UNITED STATES PATENT AND TRADEMARK OFFICE

APPLICATION NO.	FILING DATE	FIRST NAMED INVENTOR	ATTORNEY DOCKET NO.	CONFIRMATION NO.
09/752,651	12/29/2000	Robert C. Glenn	42390P9716	1502

FINAL OFFICE ACTION

Fig. 6

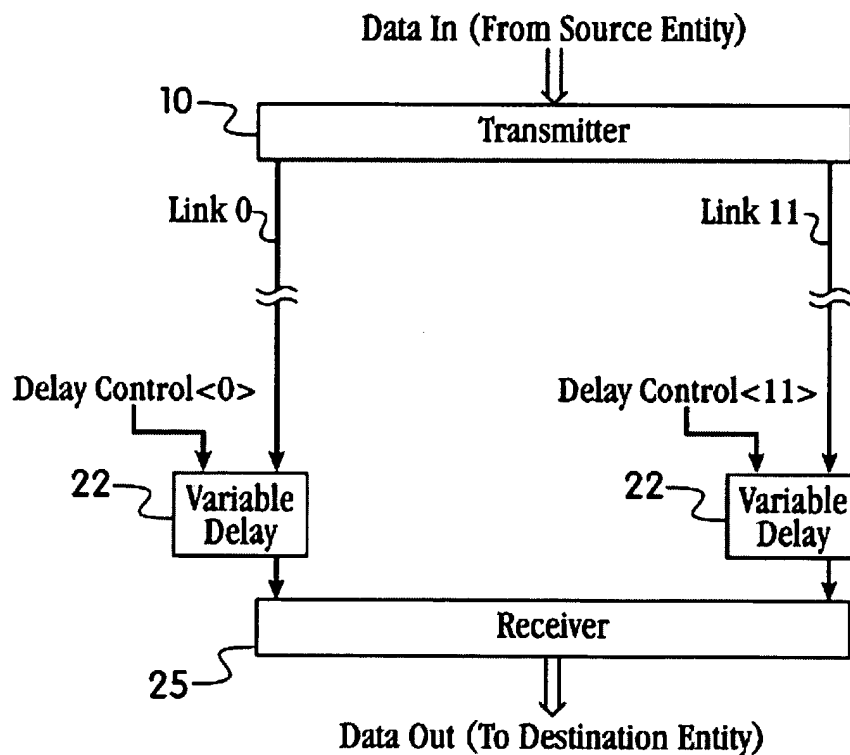
Widmer discloses, e.g., Fig. 6, skew adjustment algorithm in "Transformation of parallel interface into coded format with preservation of baud-rate" wherein

“the step of adjusting transmission delay by a dynamically adjustable delay in each transmission link may be included. The step of retiming coded data blocks on each link with a dedicated adjustable clock, and the step of eliminating skew among the links by providing a second retiming of data transferred on the links at a rate less than the predetermined baud rate with a clock system shared by all links may be included. The steps of receiving transmitted coded data blocks from the transmission lines at a receiver end is preferably included. The step of checking disparity to determine errors in the data blocks at the receiver end may be included. The step of encoding may further include the steps of outputting data blocks from each encoder to a disparity register and inputting disparity data from each disparity register to the encoder associated the disparity register to create a running disparity check of the data blocks. Further steps may include such as deserializing the serially transmitted coded data blocks at a receiver end to provide parallel coded data blocks, decoding the data blocks at a deserialized rate, the deserialized rate being lower than the predetermined baud rate and multiplexing the decoded data blocks to provide parallel data blocks at the predetermined baud rate. Each uncoded data block may include 10 bits and the predetermined baud rate may be greater than or equal to about 2 Gbaud.”

As per Claims 1, 3-29, Widmer depicts, e.g., in Fig. 6 and related description in col. 1 line 13 et seq., the claimed method, comprising: a) measuring a skew between a data signal and a clock signal at a receiving end of a serial link; and b) adjusting (col. 2 line 27) a phase relationship between said data signal (col. 2 line 30) and said clock signal (col. 2 line 29) to reduce said skew via variable delay means implementable in hardware or software, e.g., in CPU or other digital component: Refer, e.g., to Fig. 6: block 22 and col. 2 line 23 et seq.

Widmer further teaches means to impose delay on one or both signals as seen in Fig. 6. And wherein said adjusting a phase relationship further comprises adjusting a phase offset between a pair of phasors associated with a pair of phase interpolators, a first of said phasors used to derive a second clock signal that times the transmission of said data signal, a second of said phasors used to derive said clock signal in col. 2 line 27 wherein equivalent means are provided for eliminating skews via multiple values of a period to effectively result in phase interpolation means. Also refer to Fig. 6 wherein variable delay blocks 22 are configured to delay signals on the links by more than 360 degrees.

FIG. 12

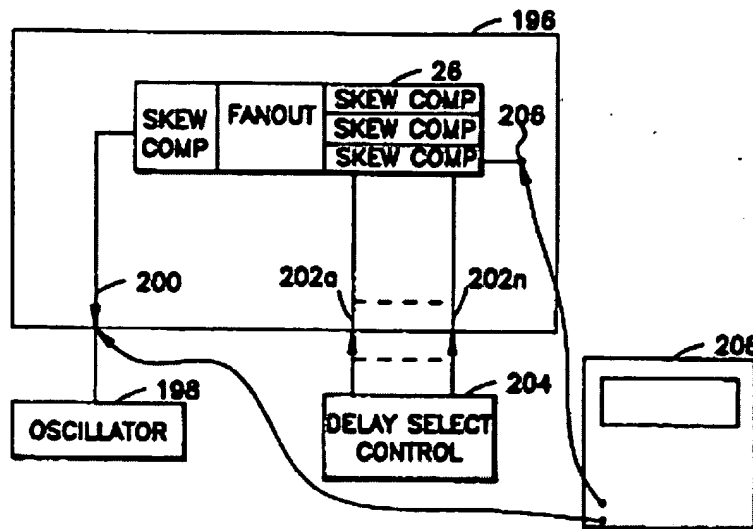
As per **Claims 1, 3-29, Nelson et al.** anticipates the claimed technique for adjusting clock skew comprising: means for measuring skew between a test/clock signal and a data signal at a destination of a link (Fig. 4 *numeral 44*), means for determining amount of skew compensation required, and means for injecting (Fig. 4 *block 26*) such amount of skew compensation into the sending side (Fig. 4 *numeral 34*) of such link, e.g., in Figs. 4 & 12 and related description at col. 1 line 8 et seq.

Accordingly, **Nelson et al.**, in an analogous art, discloses skew compensation wherein skew is detected at the receiving end of end of the serial link, such skew being compensated at the transmit end wherein such skew compensation is caused by adjusting phase of a signal. {See **Nelson et al.**, Id., e.g., Figs. 4 & 12 and col. 5 line 23 et seq.}
